DWG: ENCLOSURE SITE PLAN 01
DATE: AUGUST 21, 2023
SCALE 1: 150
ALL DIMENSIONS IN METERS

**RE: TransCanada PipeLines Limited's MLV 206 to 206A Line 200-2
CONSENT TO INSTALLATION OF STRUCTURE CAUSING A GROUND DISTURBANCE WITHIN THE
PRESCRIBED AREA OUTSIDE RIGHT-OF-WAY ("CONSENT")
Location: approx. 43.45344, -79.74191, 2270 Hilltop Lane, Oakville Ontario
Your File: PAR 50260
Our Crossing ID: D-36524-1**

2270 Hiltop Lane Oakville, Ontario Arborist Report & Tree Protection Plan

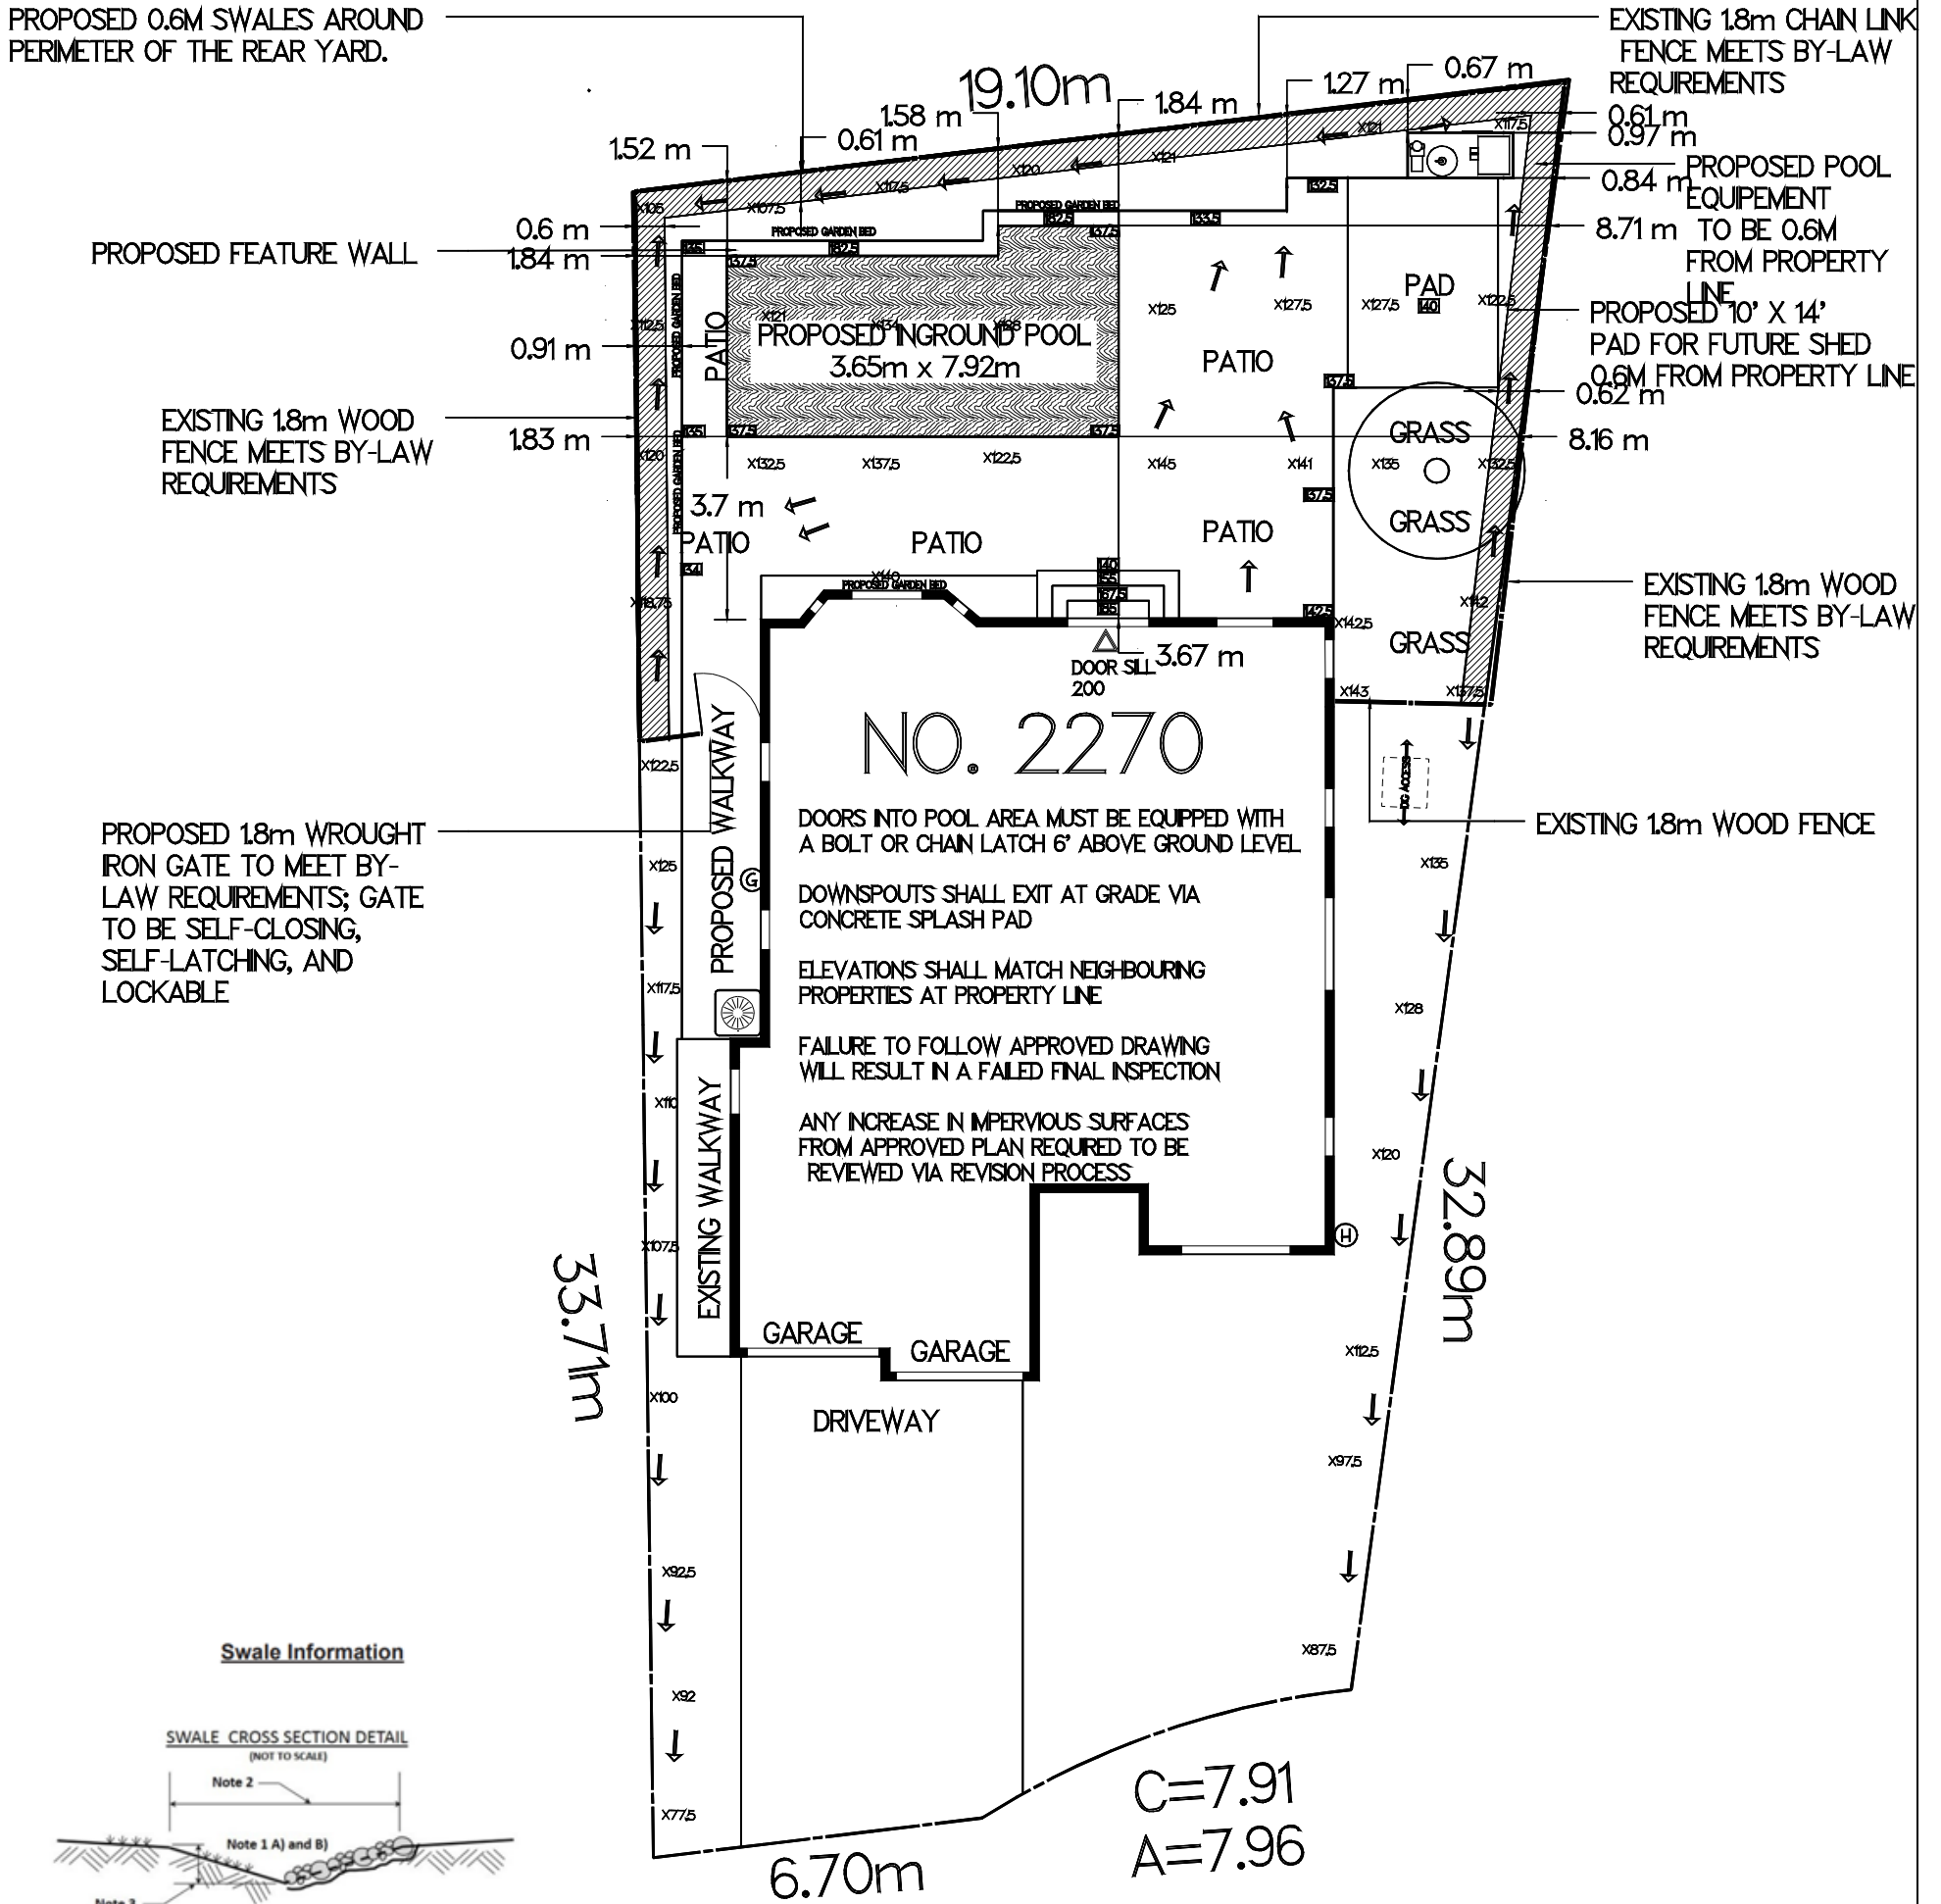
DOORS INTO POOL AREA MUST BE EQUIPPED WITH A BOLT OR CHAIN LATCH 6' ABOVE GROUND LEVEL

DOWNSPOUTS SHALL EXIT AT GRADE VIA CONCRETE SPLASH PAD

ELEVATIONS SHALL MATCH NEIGHBOURING PROPERTIES AT PROPERTY LINE

ANY INCREASE IN IMPERVIOUS SURFACES FROM APPROVED PLAN REQUIRED TO BE REVIEWED VIA REVISION PROCESS

Site Plan & Tree Protection Measures: (tree canopies and locations are approximate and not to scale)

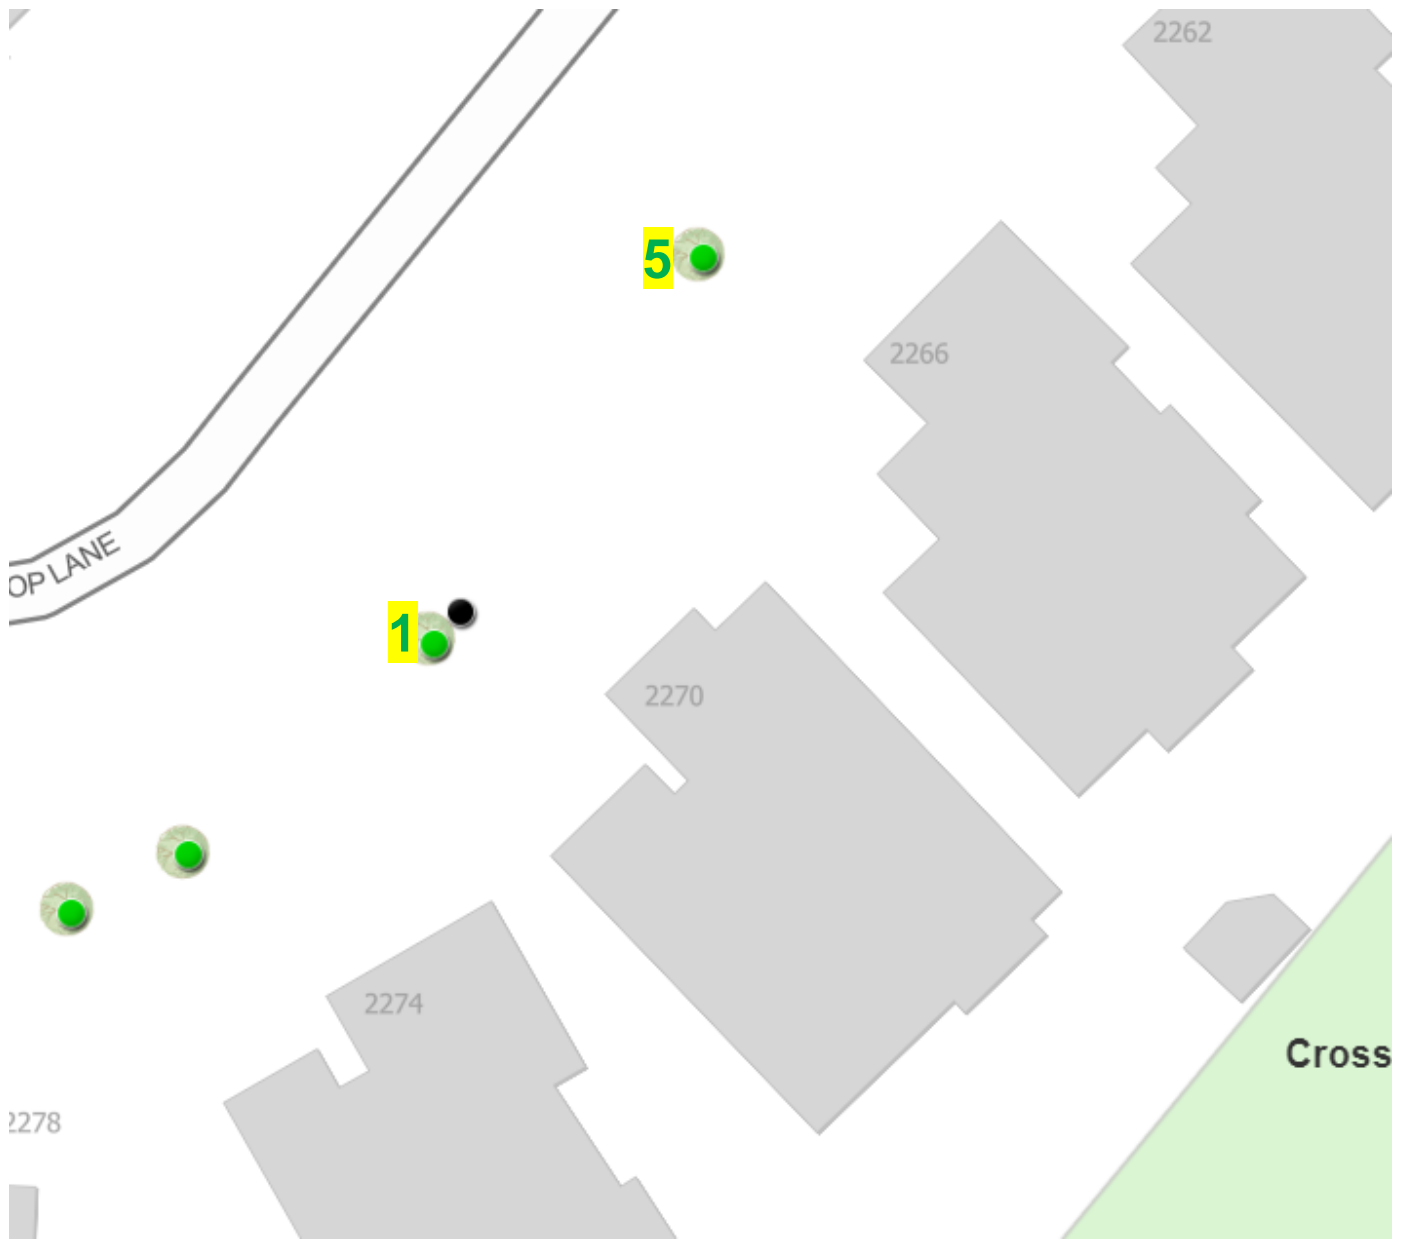
Slab on grade recommended for pad

Root Sensitive Excavation (Air Spade or hydro vac) & Root Pruning by a certified arborist prior to excavation

Root Protection Layer of woodchips and plywood or Steel Plating

The proposed construction access will encroach on the tree protection zone of privately owned tree 4. It is recommended that steel plating or a 5" layer of woodchips topped with plywood is used throughout machine use to protect the root systems from damage and/or soil compaction.

It is recommended that the proposed slab is installed on grade, to minimize excavation within the 2.4m tree protection zone of privately owned tree 4. Alternatively, ensure any excavation is outside the 2.4m tree protection zone.
